T ECHNICAL INFORMATION

64025
(page 1 of 2)

Subject	▶ Change on Motor Housing and Switch Knob in Shape
For Models	▶ 9560, 9560C, 9560CV, 9561, 9561C, 9561CV, 9562, 9562C, 9562CV, 9563, 9563C, 9563CV, 9564, 9564C, 9564CV, 9564CVL, 9565, 9565C, 9565CV, 9565CVL, BO6040, GD0800C, GD0810C
Country	▶ All countries
Description	▶ Motor Housing/Motor Housing Complete and Switch Knob have been changed in shape to improve the durability as shown below.

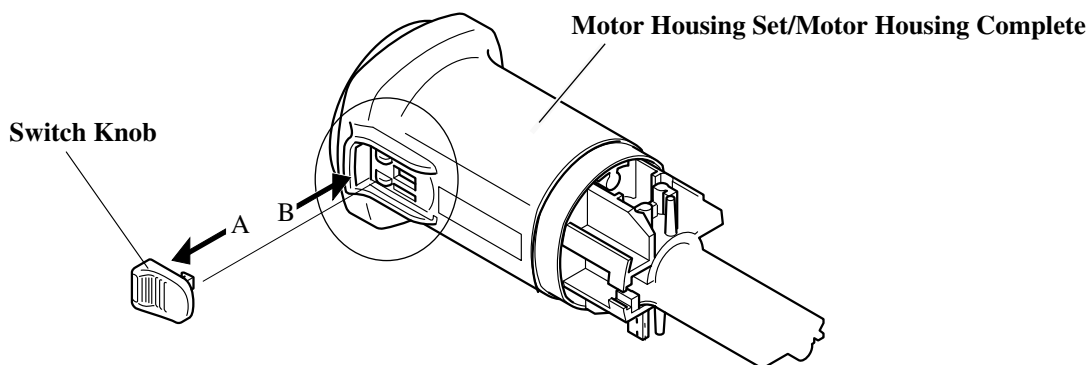
▶ Current	▶ New
Switch Knob (view from A)	<p>2.0 mm</p> <p>ribs</p>	<p>1.0 mm</p> <p>The width of the two ribs have been changed from 2.0 mm to 1.0 mm.</p>
Motor Housing (view of encircled portion from B)	<p>2.0 mm</p> <p>protruding ribs</p>	<p>4.0 mm</p> <p>The width of two protruding ribs have been changed from 2.0 mm to 4.0 mm.</p>

- 1) Makita logo label is put on the Motor Housing Sets (Part Nos. 183406-8 and 183407-6)
- 2) When replacing the current Motor Housing/ Motor Housing Complete with the new one, also replace the Switch Knob with the new one.
